COUNTY OF HENRICO  
VIRGINIA

To: Planning Office Subject: Project Isaac – POD2019-00105  
Henrico County Police Division,  
From: Community Services Unit Date: March 20, 2019

**POD2019-00105**

*<Site Plan Review>*

Photo A. Shielded wall pack.

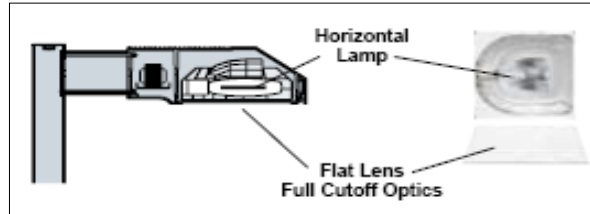
7. All light fixtures need to be full cut-off. See Photo's A and B for examples of full cut-off wall packs and pole lights.
8. Should post top fixtures be used, these fixtures also need to be full cut-off so that the light will be directed down to the ground, versus horizontally and up in the air. If decorative fixtures are installed, they should have the lamp in the top casing of the fixture so that the light will be directed towards the ground (See Photo C). This will also avoid glare because you don't actually see the lamp. Glare is defined as horizontal light that hinders vision.
